# **APPENDIX Q**

**CHARLESTON HARBOR POST 45**  
*CHARLESTON, SOUTH CAROLINA*

## **Correspondence**

29 April 2015

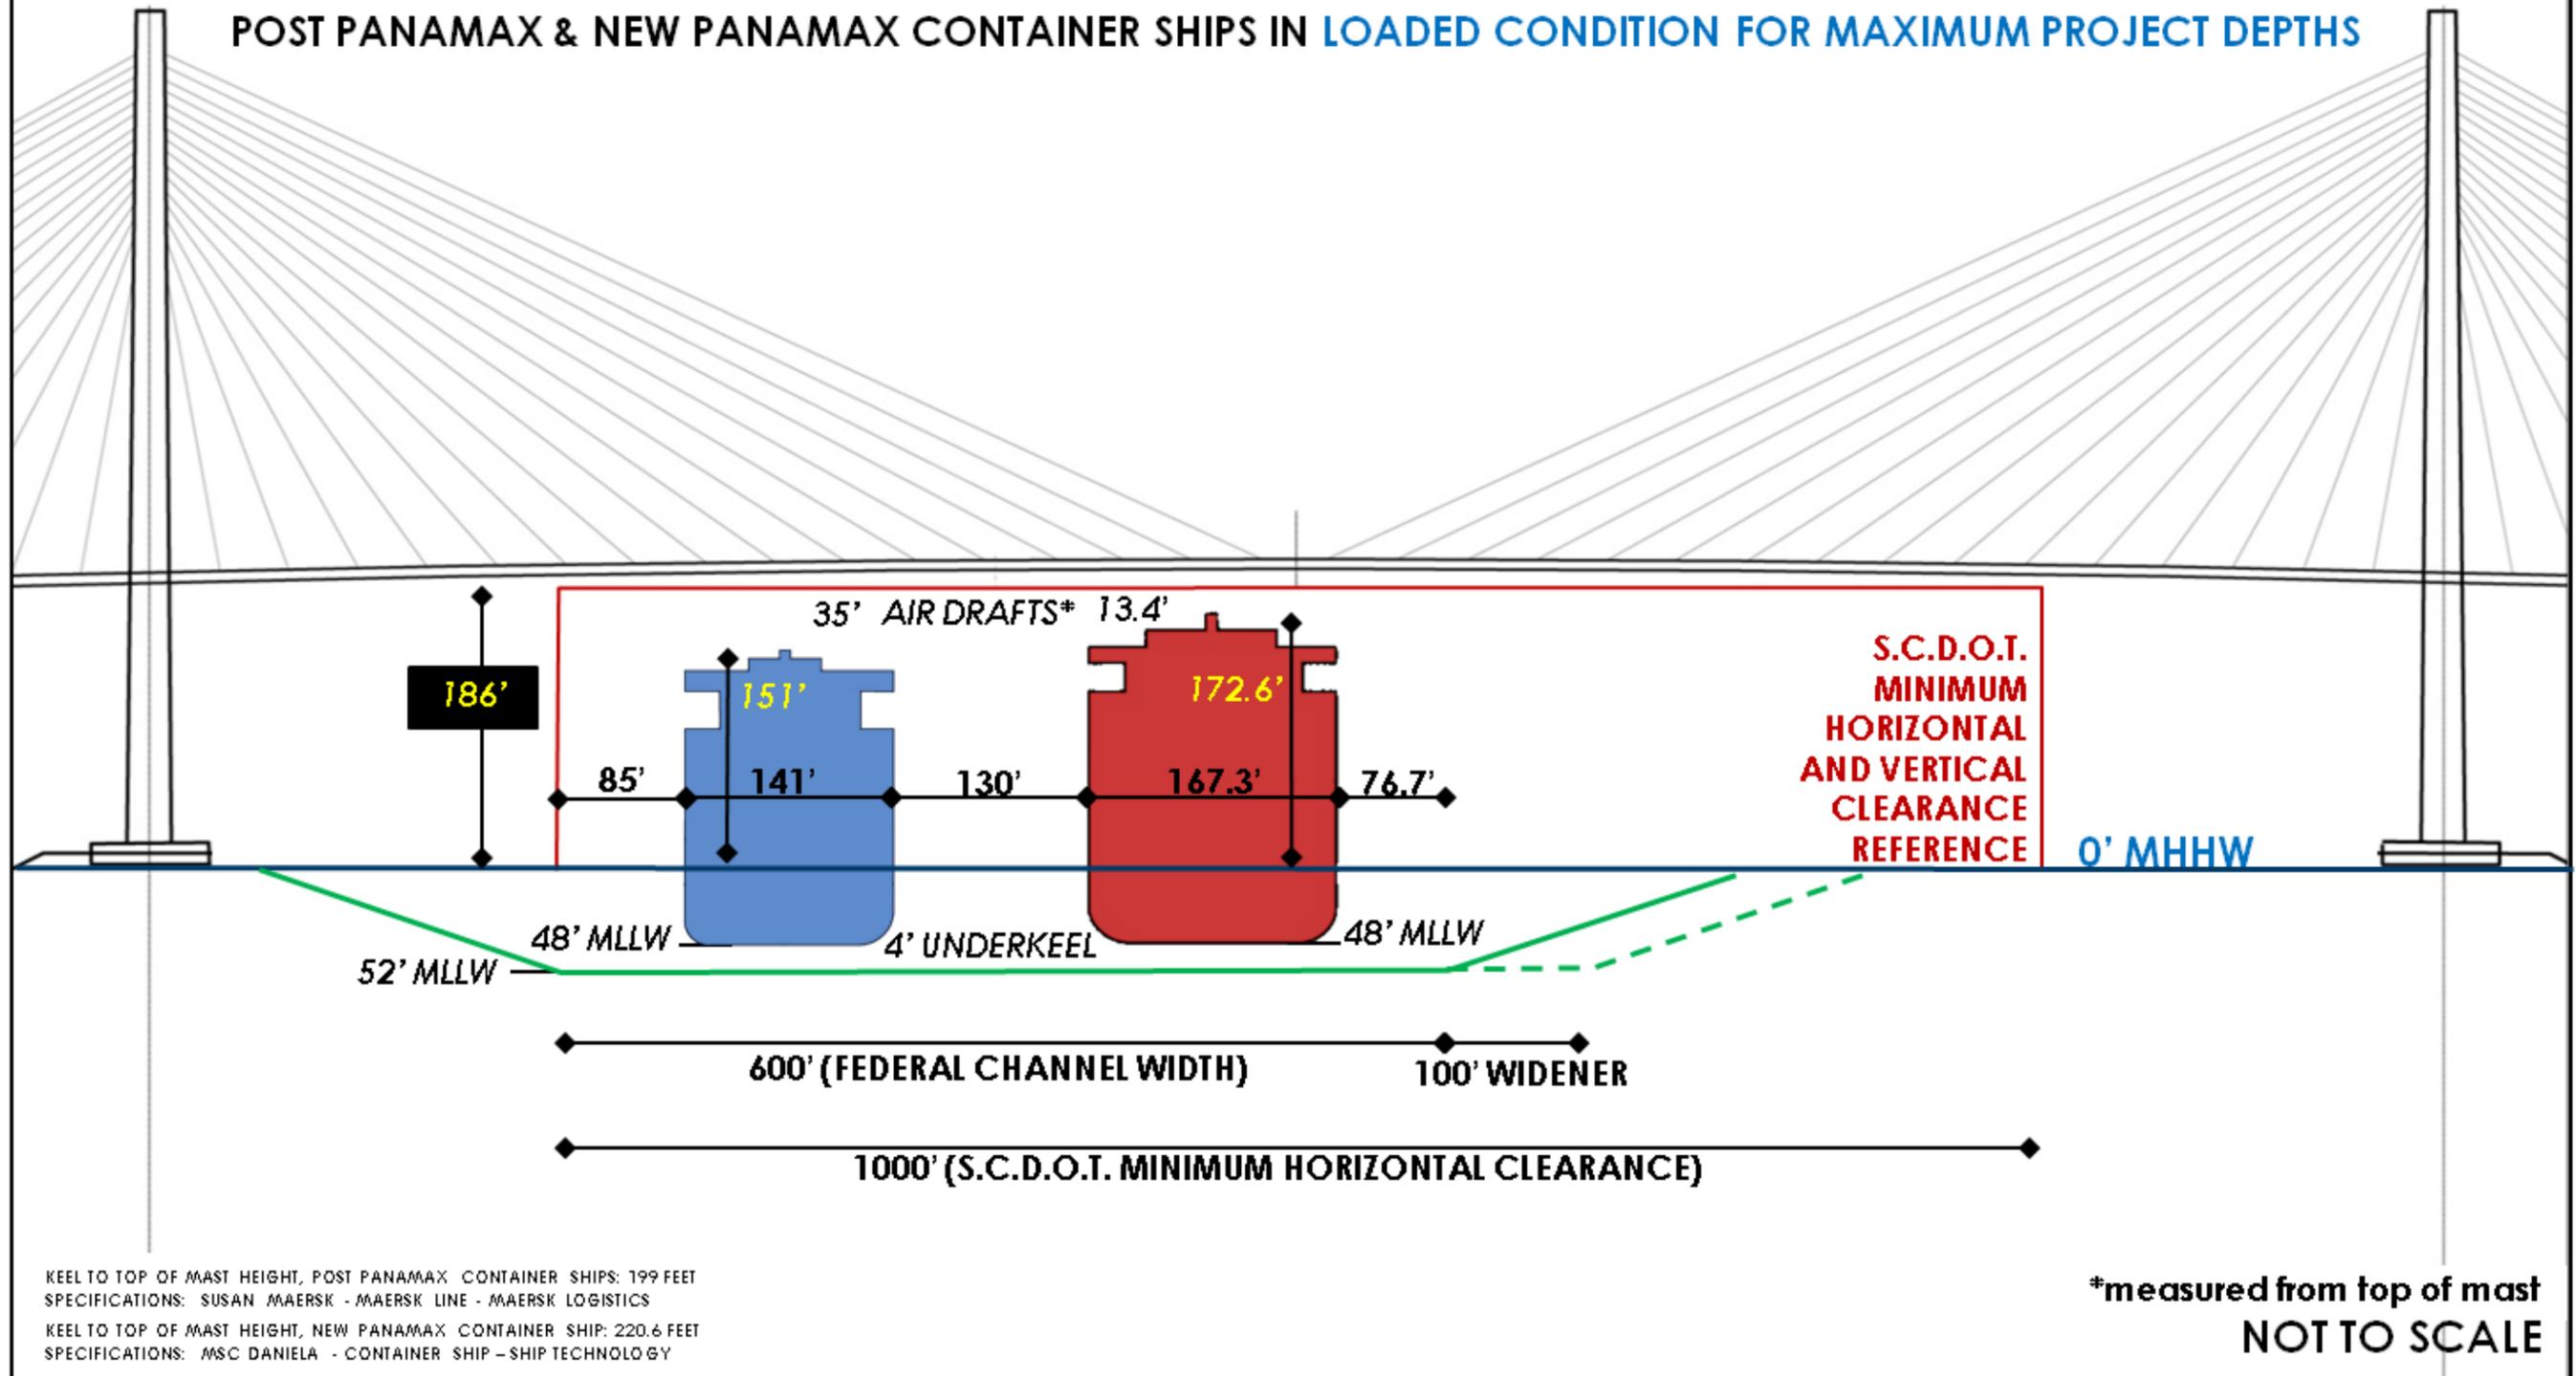
**COMMENT:** “Given the national significance of Fort Sumter and Fort Moultrie, a system of ongoing monitoring is needed, and plan for mitigation should be developed in case monitoring finds accelerated erosion. This monitoring program and plan should

be developed in close consultation with the NPS. Therefore we request additional consultations occur with the NPS to address concerns about erosion related to wave action and increased vessel traffic at Fort Sumter and Fort Moultrie.”

**RESPONSE:** Additional consultation with SCDAH and the NPS occurred. Under a Programmatic Agreement, USACE has agreed to perform monitoring before, during and for five years after construction to validate the assumptions and information used in the wave effects analysis and attempt to confirm the associated results. If adverse impacts from the project are identified, corrective action would be performed.
